<b>Docket Number:</b>	16-BSTD-06
<b>Project Title:</b>	Updates to the 2019 Time Dependent Valuation of Energy
<b>TN #:</b>	211727
<b>Document Title:</b>	WPGA Comment to CEC on Updated Propane TDV
<b>Description:</b>	Proposed correction to the propane TDV values and availability to serve as a resource for propane data.
<b>Filer:</b>	Joy Alafia
<b>Organization:</b>	Western Propane Gas Association
<b>Submitter Role:</b>	Other Interested Person
<b>Submission Date:</b>	6/6/2016 12:21:48 PM
<b>Docketed Date:</b>	6/6/2016

**SUBJECT:** Letter of Comment on CEC's 2019 Draft Time Dependent Valuation of Energy Updates

**Figure 1. Geographic Regions Contributing EIA Residential Propane Data (Excludes California & PADD 5)**

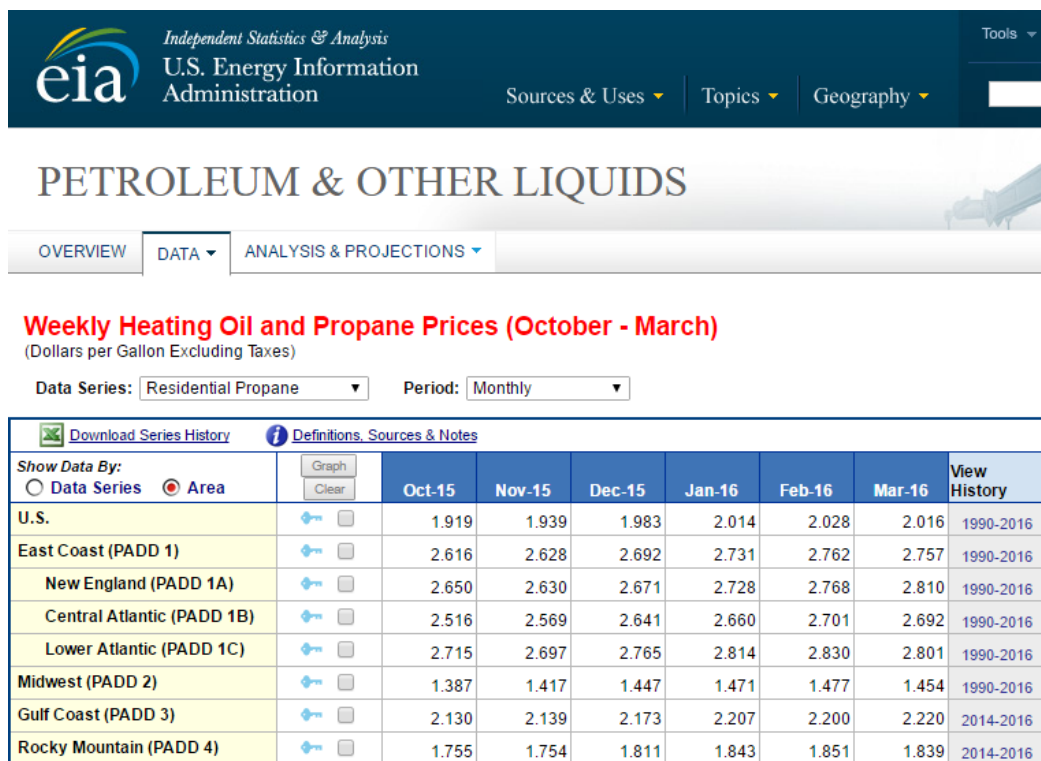
Per the EIA’s explanation of propane price data collection methods, EIA propane prices for wholesale and retail are derived from telephone surveys of marketers and refiners.<sup>2</sup> Prior to the 2014-2015 season, this sample included only data from 24 East Coast and Midwest states. In the fall of 2014, residential propane price data collection was expanded from 24 states to 38 states. However, it appears from the EIA website as though even with the recent expansion in data collection, no data is being reported on the propane prices from PADD 5. PADD 5 is the transportation fuel regional market that includes California. Figure 1 and Figure 2 display examples of the data available for residential and wholesale propane pricing. Residential propane data is available for PADDs 1 through 4, and wholesale propane data is only available for PADDs 1 and 2. Presumably, these are the same prices that factor into the EIA’s Annual Energy Outlook modeling.

Figure 3. Residential Propane Prices from EIA Data

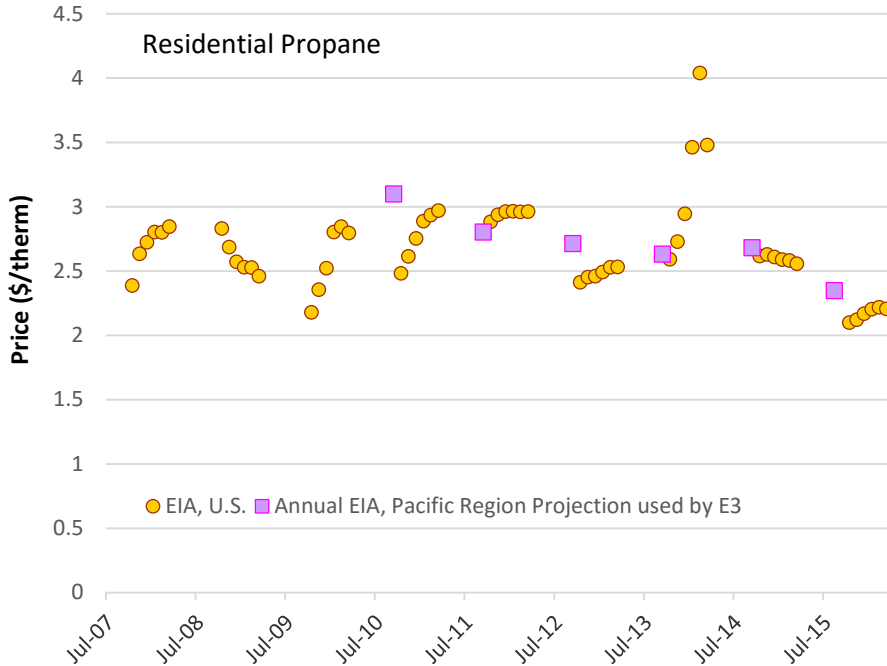
In addition, the sources of data that contribute to the EIA annual average are likely to overestimate the residential cost of propane in California. The EIA data for propane has historically relied on states that submit propane data through the State Heating Oil and Propane Program (SHOPP). Until 2014-2015, only states in the North East and Midwest were included, states with cold winters that rely heavily on residential heating. These tend to be states where propane price is much higher than in the more temperate West Coast states. In addition, every state collects SHOPP data slightly differently, making the data inconsistent and difficult to interpret. Furthermore, EIA collects data only for the winter months of October through April. It is very important to note that October through April are the months when propane prices are highest. An annual average based on these 6 months would greatly overestimate the cost.

As shown in Figure 3, EIA data is only collected during the winter months of the year. The annual average EIA AEO projections for the Pacific region is shown in the pink squares. This chart shows how the EIA data excludes the lower price summer months in which propane would provide fuel for residential applications such as water heating and distributed power generation.

**Figure 4. Propane Cost**

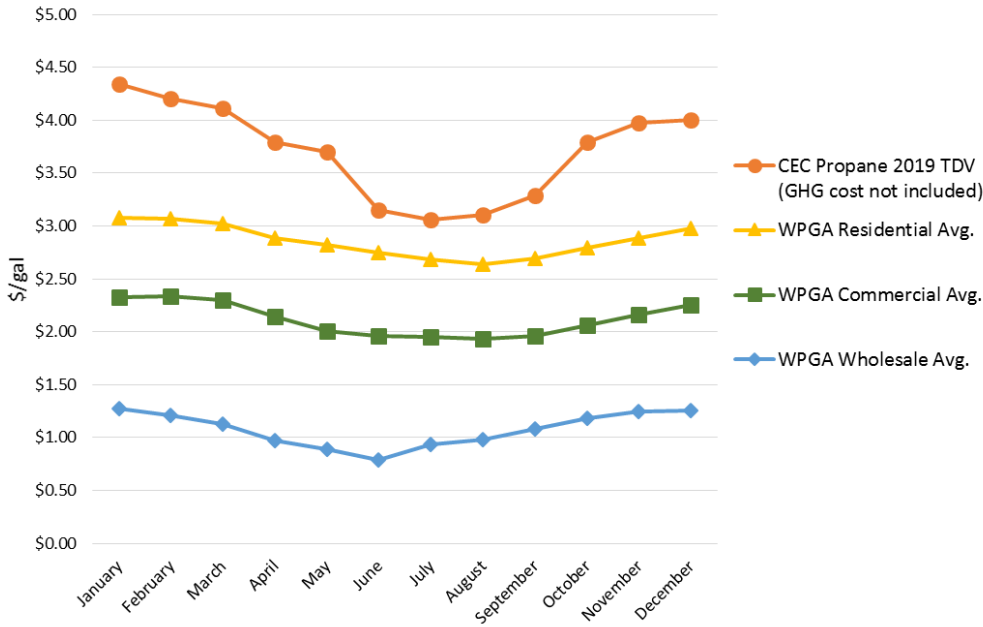
While the methodology used to convert EIA commercial and residential propane prices is not clear from the published CEC documentation, the resulting propane TDVs appear to far exceed WPGA member data on average propane prices at all retail levels. WPGA members provided monthly pricing data on wholesale, residential retail, and commercial retail propane from 2009 through 2015. At every retail level, the 6 year annual monthly price members report receiving is lower than the price suggested by the CEC TDV values shown in the May 12, 2016 Updated 2019 TDV presentation.

Figure 4 shows a comparison of the cost of different types of propane in terms of dollars per gallon over a calendar year. The top line shows the CEC 2019 TDVs for propane taken from the Updated TDV presentation on May 12, 2016. The cost of GHG emissions has been subtracted from the total TDV cost, leaving only what is labeled as "delivered propane." The units have been converted from dollars per therm to dollars per gallon based on an assumed higher heating value of 91,420 Btu/gal. The second line shows WPGA member data on the average residential propane sales price in California between 2008 and 2015. The third line shows WPGA member commercial propane sales prices in California during the same period. The fourth line shows WPGA member average wholesale propane sales price in California from 2009 through 2015. This graph clearly shows that the CEC prices are consistently higher than any of the prices observed by WPGA members, even at the residential retail price. The difference between TDV and WPGA residential averages ranges from about \$0.35 to as much as \$1.25.

**Figure 5. Propane Supply Forecast**

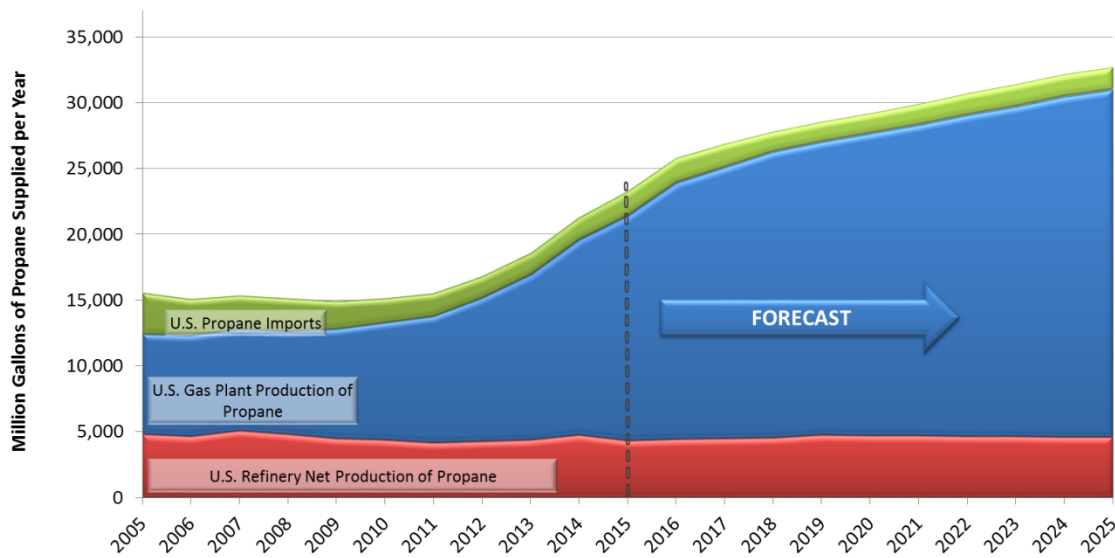
The CEC's propane price forecast appears to be much higher than historical WPGA member and EIA show, as demonstrated previously. Furthermore, propane supplies are expected to grow with increased production from natural gas and crude oil production. As gas processing plants are added to new oil and gas production, projections of the U.S. supply of propane is expected to double as indicated in Figure 5. Such a growth in supply would put downward pressures on price.

Figure 6. Propane Space Heated Households

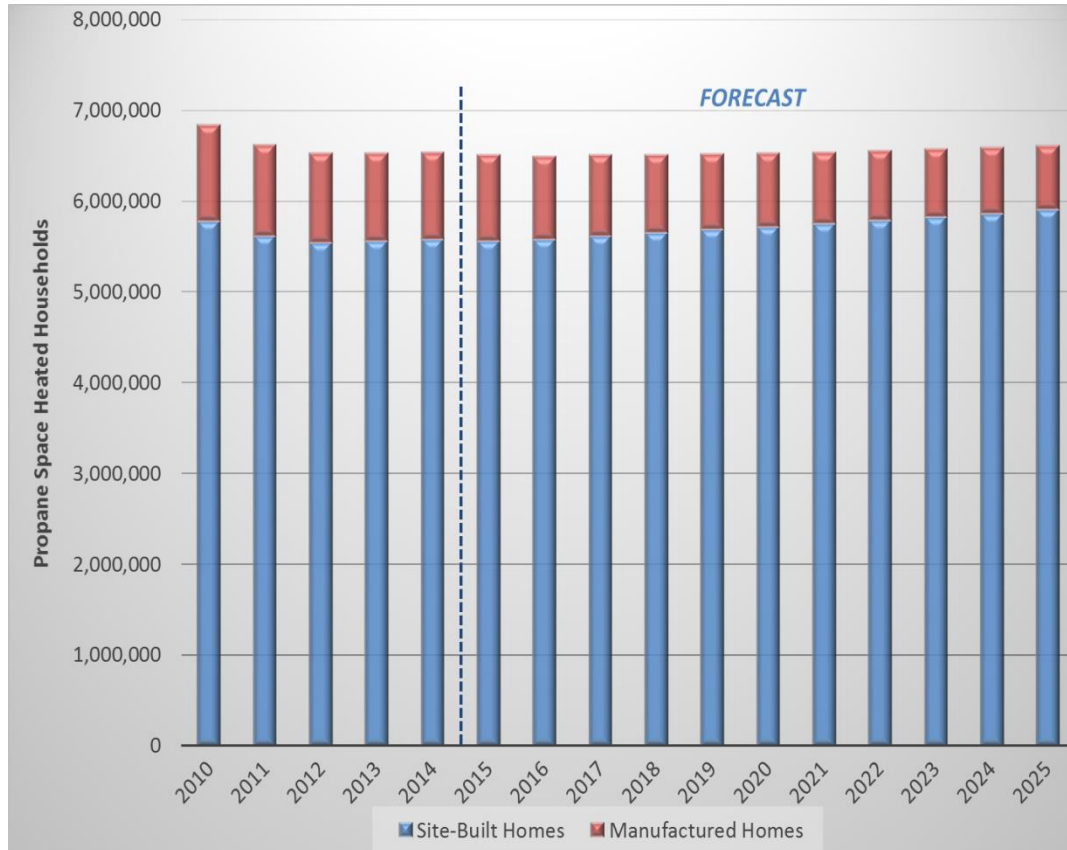
The residential market in particular is expected to grow. Propane site-built space heated households increased from 5.54 million in 2012 to 5.57 million in 2014, and are projected to increase to 5.90 million by 2025, as demonstrated in Figure 6.

Figure 7. Seasonal Propane Price Variability

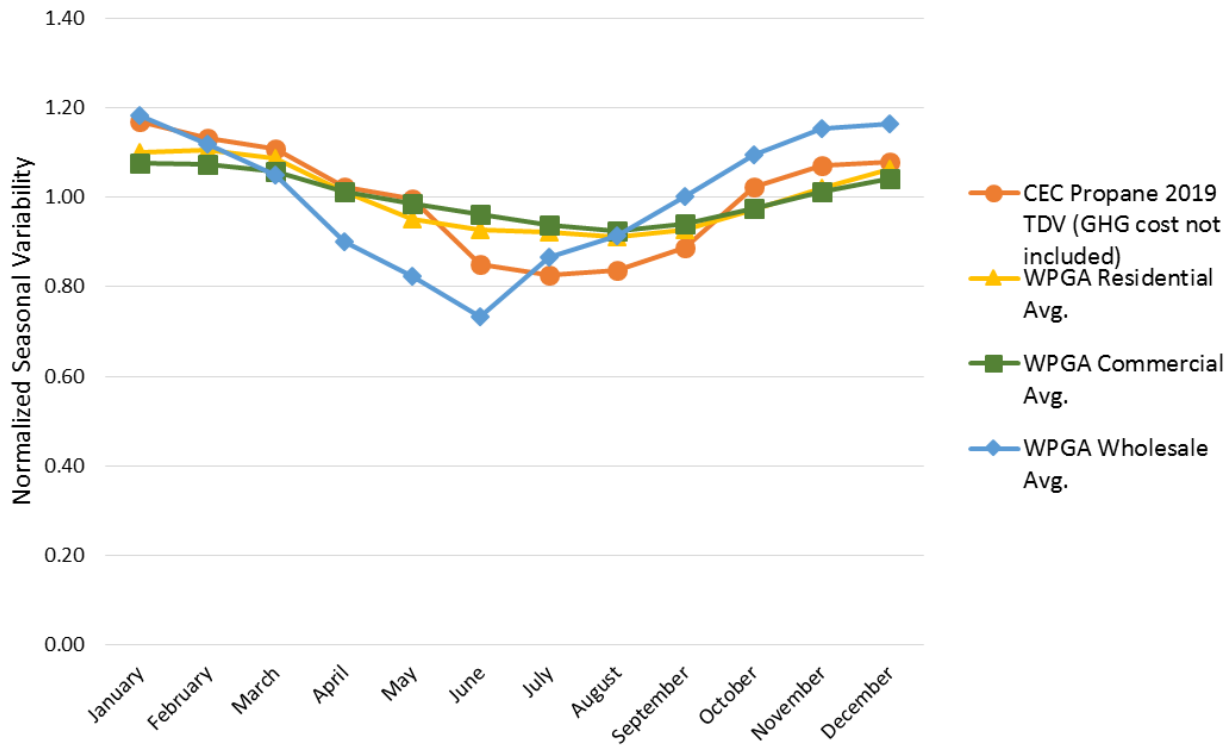
Seasonal variability is predicted by CEC to be much higher than that which has historically been observed in residential and commercial pricing by WPGA members over time.

Propane gas price varies seasonally due to reduced heating demand in the summer. WPGA compared member data on the wholesale, residential, and commercial propane pricing from 2010 through 2015 to the seasonal variation in price to the CEC TDV values proposed for the 2019 TDV Update. The normalized seasonal variability was calculated based on the ratio of the average of all available months over the average of all data points available for each type of propane. The same calculation was performed on the CEC proposed propane TDV values. This unitless ratio provides insight into the range of seasonal variation in price from year to year. Data points closer to one show less variability, and data points farther from one show more.

Figure 7 shows the seasonal variability displayed in the four different types of propane pricing. The CEC ratios appear to most closely mirror the wholesale seasonal price variability, showing a large swing in price between summer and winter months. However the residential and commercial prices reported by WPGA members appear to be far more stable throughout the year.

**Figure 8. Natural Gas and Propane Avoided Cost 2019 TDVs**

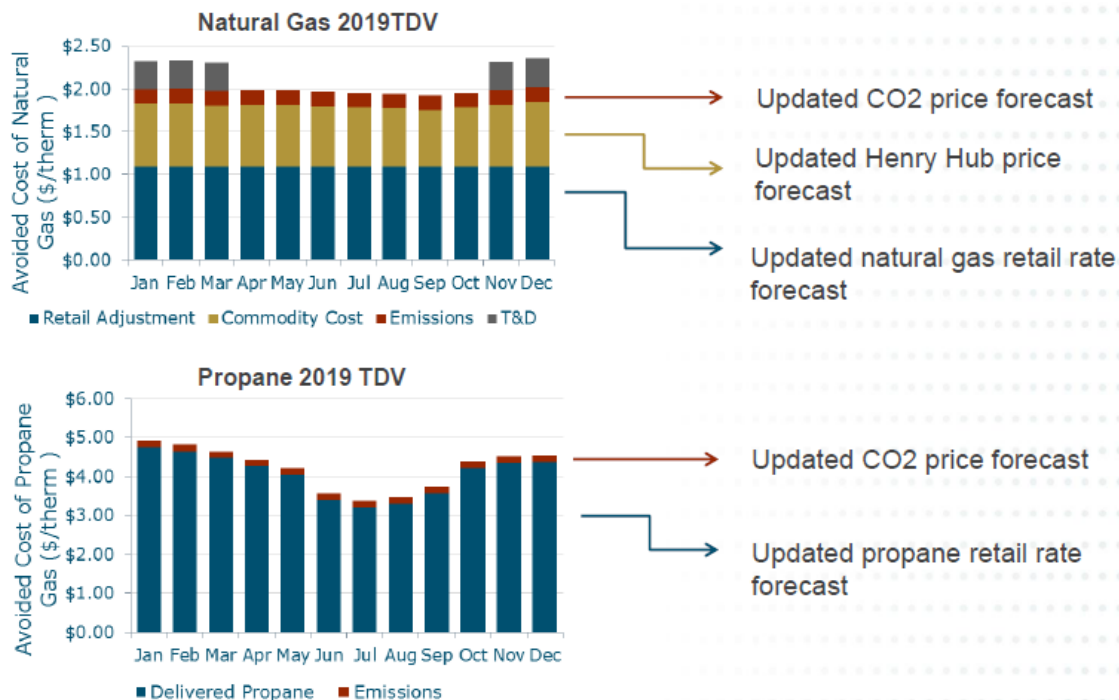
CEC analysis should clearly distinguish between different components of the value chain in propane TDVs.

In order for WPGA to more effectively comment on the proposed TDVs, it would be helpful if the CEC could clearly delineate between the different life cycle phases that contribute to the overall avoided cost. As shown in Figure 8, the May 12, 2016 presentation slides showed the natural gas TDV broken down into the contributing factors of retail adjustment, commodity cost, emissions cost, and transport and distribution. However, the propane TDV graph shows only the contribution of emissions cost and delivered propane. This makes it impossible for WPGA to assess the accuracy of the different aspects of the life cycle cost, such as retail markup and transport and distribution cost.
